### LEVY COUNTY NUCLEAR POWER PLANT, UNITS 1 AND 2 DOCKET NOS. 52-029 AND 52-030 PARTIAL RESPONSE TO REQUEST FOR ADDITIONAL INFORMATION LETTER NO. 034 RELATED TO BASIC GEOLOGIC AND SEISMIC INFORMATION

# Levy Nuclear Power Plant Units 1 and 2 Response to NRC Request for Additional Information Letter No. 034 Related to SRP Section 2.5.1 for the Combined License Application, dated May 8, 2009

### NRC RAI #: 02.05.01-32

#### NRC RAI #: 02.05.01-37

Revised Figure 2.5.1-209

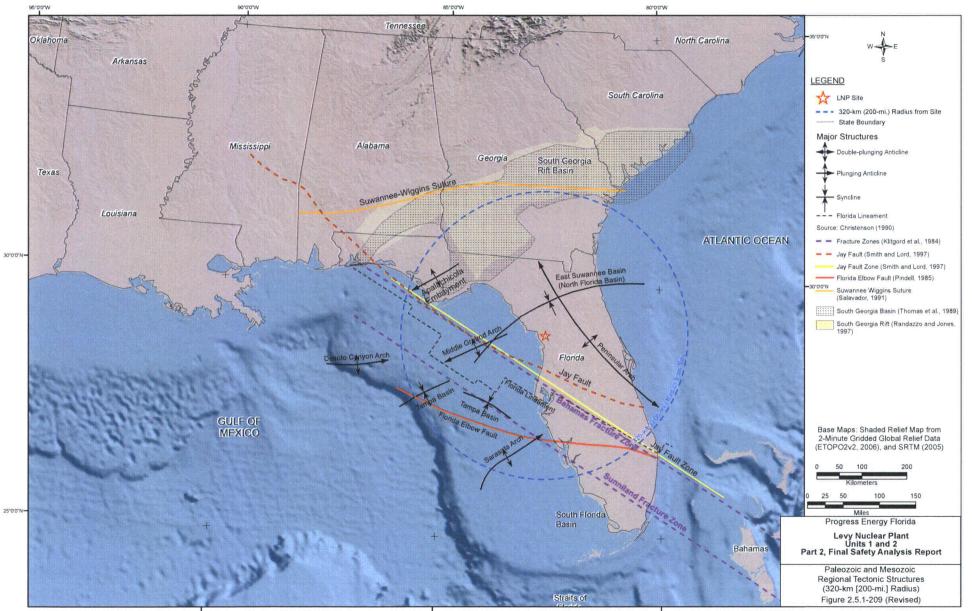
FSAR Section 2.5.1.2.2 (pg 2.5-65) discusses geologic history of the site vicinity and cites FSAR Figures 2.5.1-208 and 2.5.1-209 as showing the South Georgia basin. However, neither figure appears to locate this feature.

In order for the staff to understand geologic history of the site vicinity, please locate the South Georgia basin on the figures cited.

The Mesozoic South Georgia basin will be added to Revised Figure 2.5.1-209 in a future revision.

Figure 2.5.1-209 is being revised to show the Mesozoic South Georgia basin in addition to other changes for RAI 02.05.01-18.
